# Y2K FIRMWARE UPGRADE KITS FOR DANTEL MULTIPLE ALARM PROCESSORS

**46020-38, 46020-40, 46020-41,  
46800-24, 46639-01, 46800-48,  
46800-50, 46800-58**

This practice has been reissued to:

- Update the -38 firmware eeprom number from D82 to E82.

FIG. 1 - 46020 MAP EPROM LOCATION (FOOTPRINT 1)

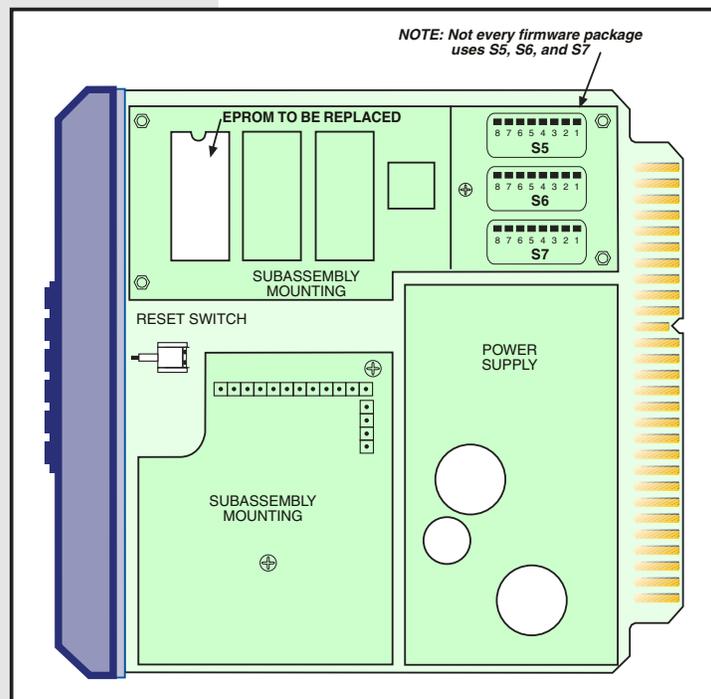
1. Remove the module to be upgraded and place the module on an ESD approved work area. The component side should be up and the blue handle to the left.
2. The EPROM(S) to be removed is located in the top left corner of the module (Refer to Fig. 1). Before removing this chip, note its orientation. (The notch is toward the top of the module.)
3. Remove the old EPROM(S) by pulling straight up on the IC. It may be necessary to use a small screwdriver to gently pry the old EPROM(S) up.
4. Set the old IC(s) to the side.

1. Install the replacement EPROM in the socket. Verify that the orientation is the same as the old EPROM (refer to Figs. 1 and 2.)
2. Applying even pressure, push the IC into position. Exercise caution not to bend any pins on the IC.

FIG. 2 - 46020 MAP EPROM LOCATION (FOOTPRINT 2)

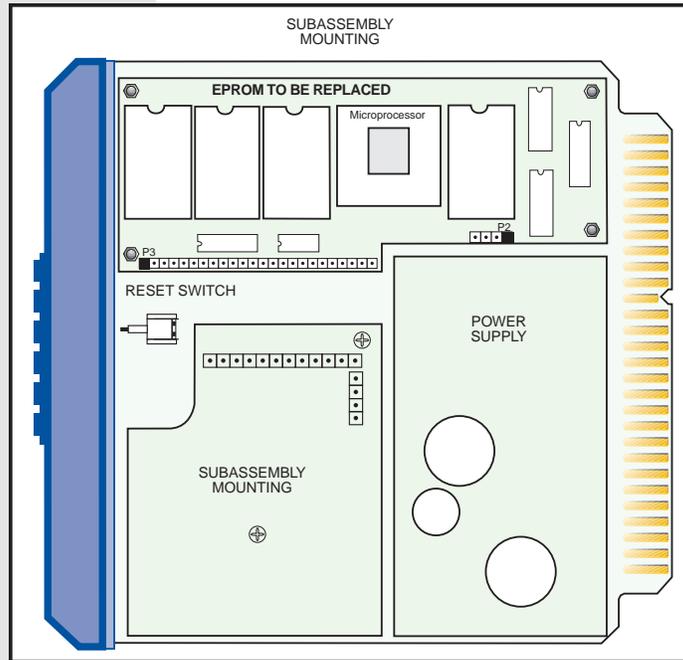
*\* NOTE: Different firmware packages are laid out differently. Refer to Figs. 1 or 2 to locate the EPROM for your firmware package.*
